REMARKS

In the non-final Office Action mailed May 01, 2007, claims 1-16 remain pending in this application. Claims 1-8, 13, 14 and 16 stand rejected. Claims 9-12 and 15 have been objected to. With this Amendment, claims 1, 3-7, 9, 13 and 15 have been amended. No new matter has been added. Reconsideration of the present application in view of the amendments and remarks that follow is respectfully submitted.

FIG. 4

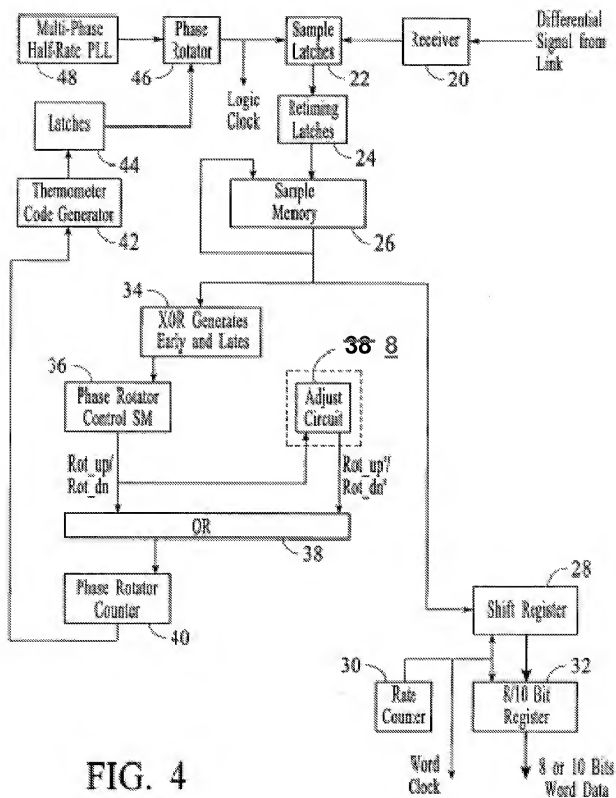
Figure 4 has been objected to by Examiner due to a 'reference number "38" being used to designate both an "OR" block and an "adjust circuit"' in the referenced figure. Applicant has corrected Examiner's cited objection and has included as a part of this Amendment a Replacement Sheet for Figure 4 where Applicant has maintained the use of reference number 38 for the "OR" block and has corrected the reference number for the "adjust circuit" to be "8," which is correctly referenced in the Specification.
